Access Compliance Report

Public Rights-of-Way

(Curb Ramps)

Intersection ID: N/A	Main Street: E_W_T_HARRIS_BV	Cross Street: N/A	Location: SE
ADA ID: F39C6BB95838	Ramp Type: PerpDiag	Initial Pass/Fail: Fail	Overall Compliance: No
		Severity Score: 10

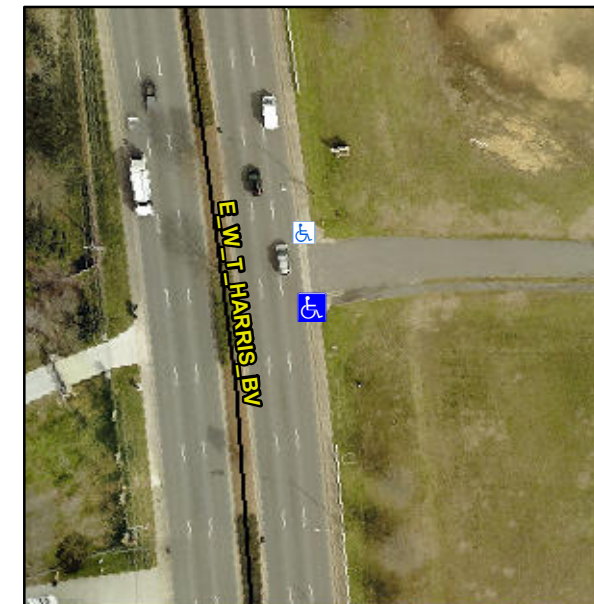
Not Found, R304.5.1

Compliance	Description	Data	Compliance	Description	Data
N/A	Ramp Length (in)	80.0	Yes	Ramp Slope (%)	6.5
No	Ramp Width (in)	40.0	Yes	Ramp XSlope (%)	3.7
N/A	Flare Type LT	N/A	N/A	Flare Type RT	N/A
N/A	Flare Slope LT (%)	N/A	N/A	Flare Slope RT (%)	N/A
N/A	Flare Traversable LT?	N/A	N/A	Flare Traversable RT?	N/A
N/A	Landing Length (in)	N/A	N/A	DWS Provided?	N/A
N/A	Landing Width (in)	N/A	N/A	DWS Contrast?	N/A
N/A	Landing Slope (%)	N/A	N/A	DWS Length (in)	N/A
N/A	Landing X Slope (%)	N/A	N/A	DWS Full Width?	N/A
N/A	Landing Curb? (Y/N)	N/A	N/A	DWS Offset (in)	N/A
N/A	Shared Landing?	N/A			
N/A	Gutter Ponding?	N/A	N/A	Gutter Slope (%)	N/A
N/A	Gutter Lip Ht (in)	N/A	N/A	Gutter X Slope (%)	N/A
N/A	Painted X Walk1?	No	N/A	Painted X Walk2?	No
	X Walk 1 Direction	To N		X Walk 2 Direction	To W
N/A	X Walk 1 Width (in)	N/A	N/A	X Walk 2 Width (in)	N/A
	X Walk 1 Slope (%)	2.0		X Walk 2 Slope (%)	3.8
	X Walk 1 X Slope (%)	3.3		X Walk 2 X Slope (%)	1.2

N/A	Ramp inside XWalk1?	N/A	N/A	Ramp inside XWalk2?	N/A
	Road Slope (%)	4.6	N/A	Clear Space?	N/A
	Road X Slope (%)	4.4	N/A	Clear Space to XWalk (in)	N/A
N/A	Any Obstructions?	N/A	N/A	Storm Grate/Utility Hazard?	N/A
	Obstruction Type			Storm Grate/Utility Type	
		N/A			N/A
			Yes	Surface Condition? (G/P)	Good

Remove & Replace Curb Ramp With Two New Directional Ramps or Equivalent.
